STATE OF OHIO  
DEPARTMENT OF HIGHWAYS  
ALTERATIONS TO BRIDGE OVER  
HURON RIVER IN VILLAGE OF HURON

PET. No. 6944

ERIE COUNTY

**FLOOR BEAMS & STRINGERS**  
 FOR A  
**SCHERZER ROLLING LIFT BRIDGE**  
 ACROSS  
**HURON RIVER**  
 AT  
**HURON, OHIO.**  
 FOR THE  
**COUNTY OF ERIE**

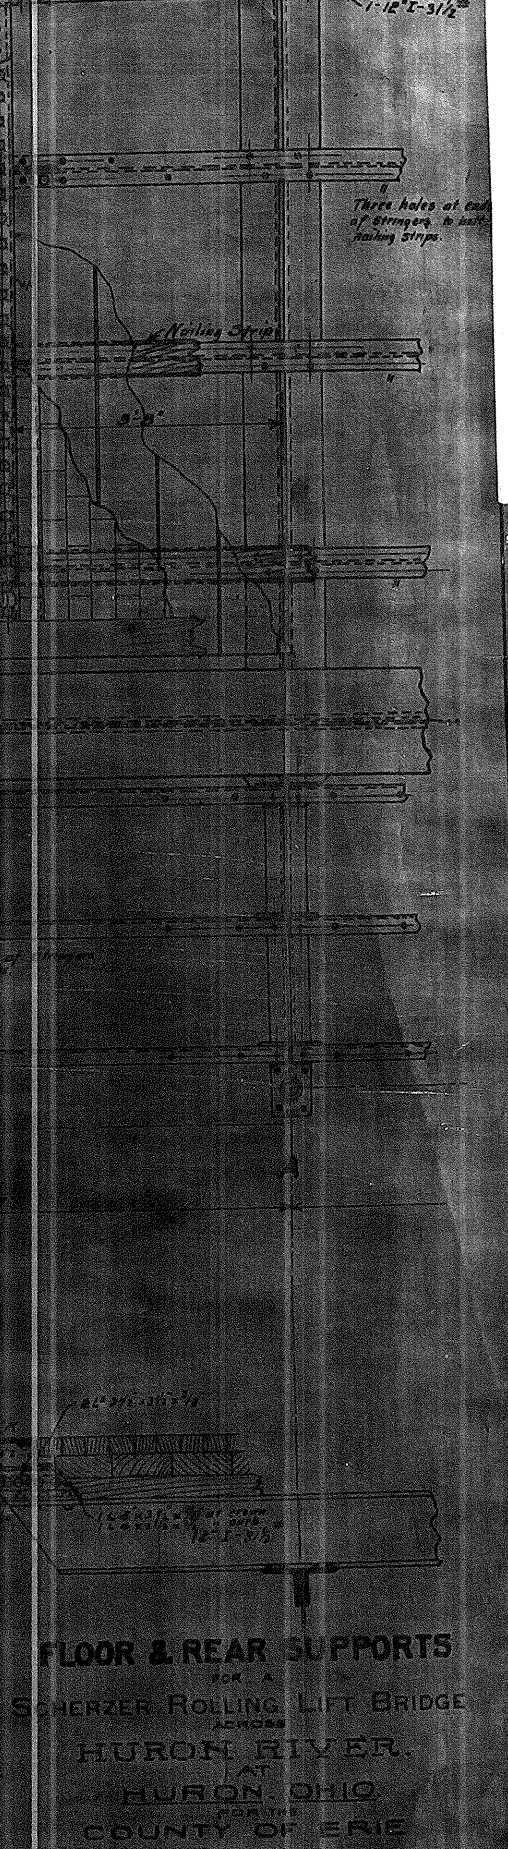
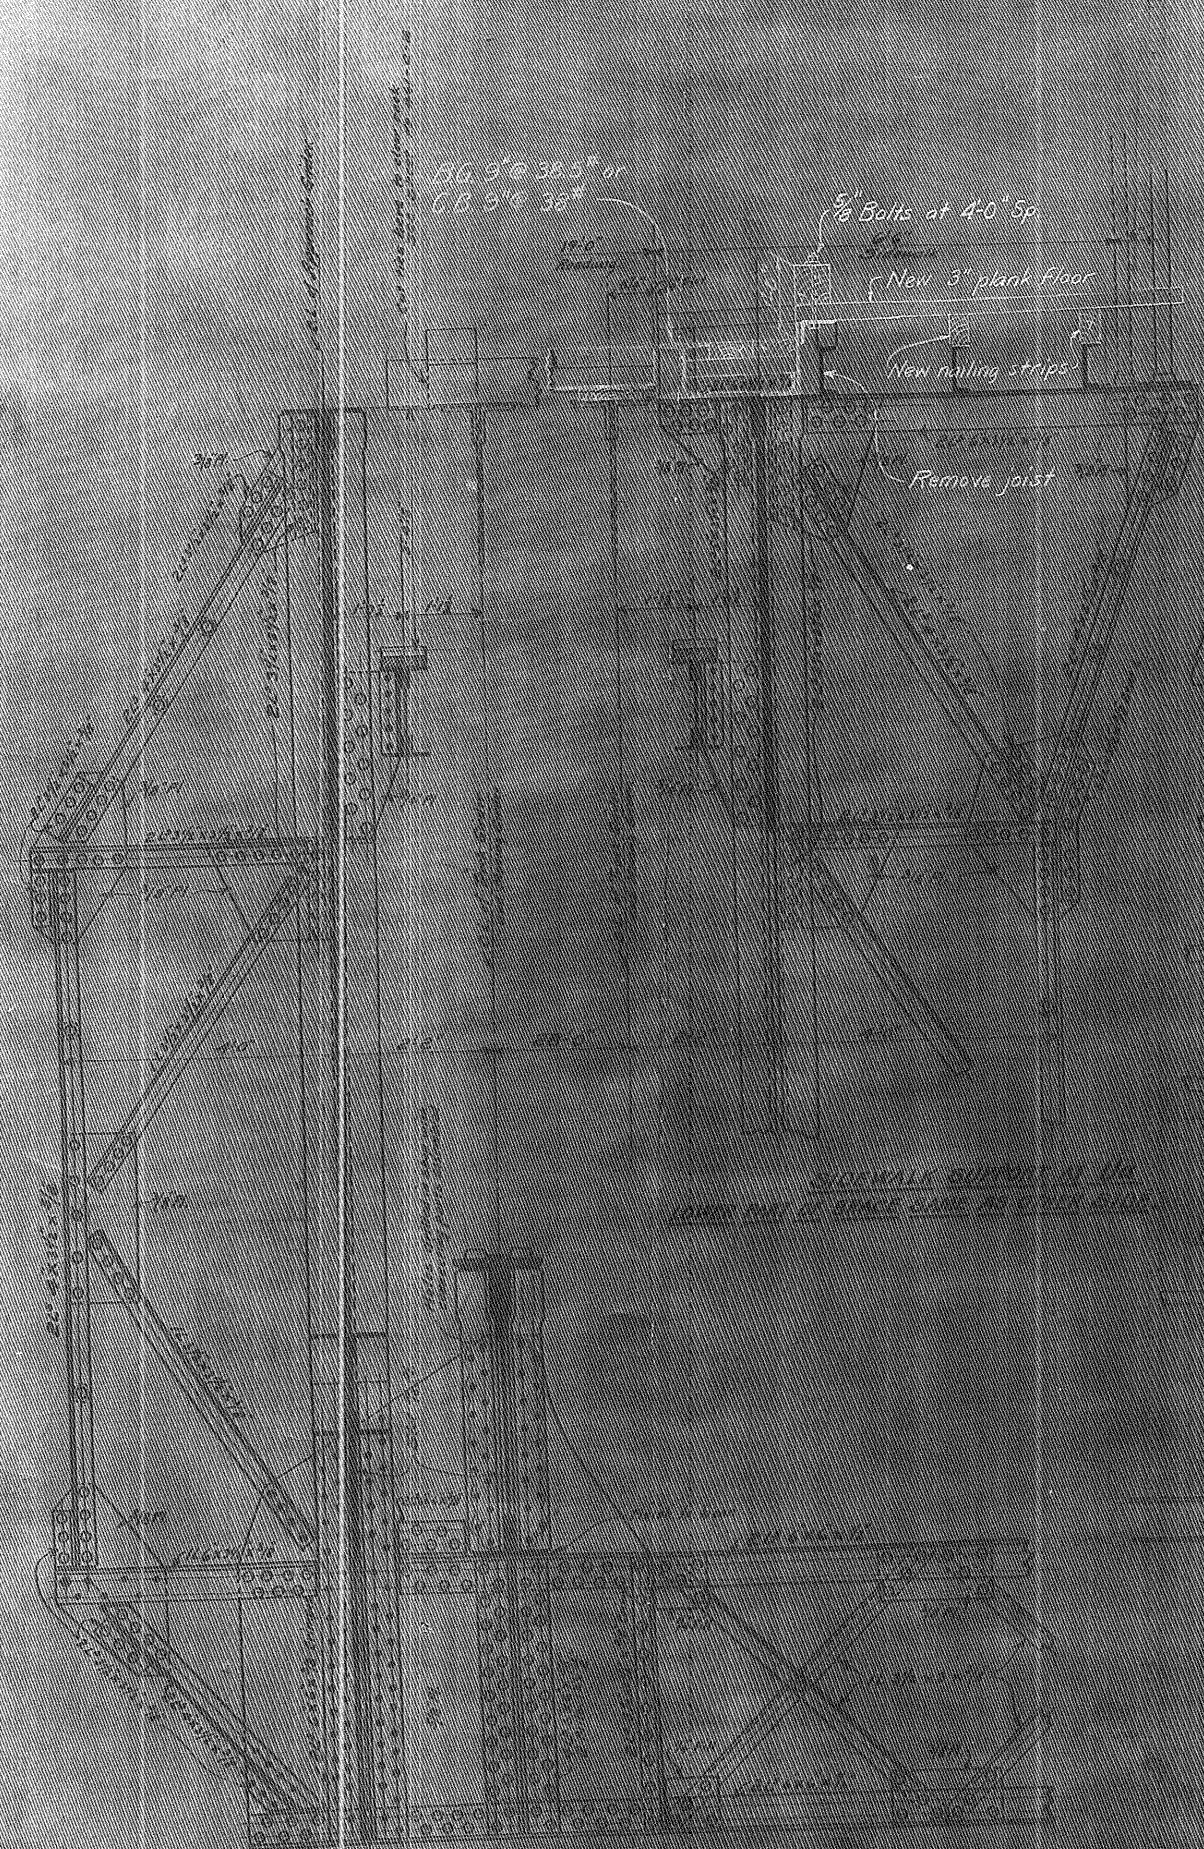
The proposed work on the highway and sidewalk portion of this bridge is described both by the specifications on this sheet and by sketches on the attached photographic prints. These latter were made from blueprints of two of the sheets of the original bridge plans, with the new work sketched thereon. Because of the special nature of much of this work, it shall be carefully studied by the contractor in collaboration with the Resident Engineer, and all details not specifically described, but necessary for a proper execution of the work, shall be taken care of in a satisfactory and workmanlike manner. All alterations shall be so made as not to interfere with the proper operation of this structure as a movable bridge. Alterations may be made from details as proposed, if approved by the Bureau of Bridges.

Alter End Finish to fit  
floor construction
